CHANGE REQUEST

⌘ **33.246 CR 038** ⌘ rev **-** ⌘ Current version: **6.1.0** ⌘

Title:	⌘ Clarify MUK key synchronisation for MSK push procedure		
Source:	⌘ Siemens		
Work item code:	⌘ MBMS	Date:	⌘ 14/02/2005
Category:	⌘ C	Release:	⌘ Rel-6
	Use <u>one</u> of the following categories: F (correction) A (corresponds to a correction in an earlier release) B (addition of feature), C (functional modification of feature) D (editorial modification) Detailed explanations of the above categories can be found in 3GPP TR 21.900 .		Use <u>one</u> of the following releases: Ph2 (GSM Phase 2) R96 (Release 1996) R97 (Release 1997) R98 (Release 1998) R99 (Release 1999) Rel-4 (Release 4) Rel-5 (Release 5) Rel-6 (Release 6) Rel-7 (Release 7)

Figure 6.3: Pushing the MSKs to the UE

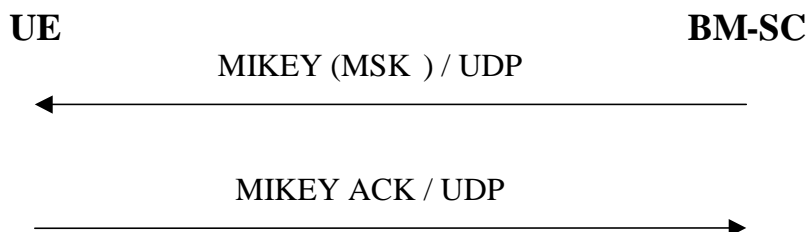
Reason for change:	⌘ It may happen that the UE has already generated a new MUK/MRK pair (after a GBA run and the subsequent application NAF derivation step) but the BM-SC was never informed. From the BM-SC point of view his known MUK/MRK pair may still be valid (lifetime has not expired), hence this MUK-ID can still be used within the MSK push procedure. While the UE has already installed a new MUK-ID, the BM-SC is using an old MUK for protecting the MSK push MIKEY messages. The UE behavior for this mismatch case is not specified. A similar handling as for the push solicited pull procedure is proposed. For the push solicit pull, the BM-SC is allowed to use a MUK-ID beyond the SA-lifetime (differently than the last generated one). This MUK-ID is known to the UE as the last-successfully used.
Summary of change:	⌘ Clarify the UE behavior when receiving a normal MIKEY push message with an old (still valid) MUK-ID. The UE shall handle the MIKEY push message in a similar way as the push solicited pull message. This guarantees that the UE contacts the BM-SC with the B-TID. Subsequently the MSK is pushed again to the UE (yet with the newer MUK).

When an MSK push MIKEY message is not directly preceded by an MSK key request, then it may happen that the BM-SC uses a still valid MUK that is not the last generated MUK at the UE. The UE shall handle such a MIKEY push message in a similar way as the push solicited pull MIKEY message (i.e upon a successful integrity check the UE shall initiate an MSK request with the specified Key Group).

NOTE: This procedure guarantees that the UE contacts the BM-SC with the last B-TID, such that the UE now receives a MIKEY push message with the last generated MUK. The integrity of the initial pushed MIKEY message can be verified at the UE with the MUK-ID that is known as the last successfully used BM-SC MUK-ID.
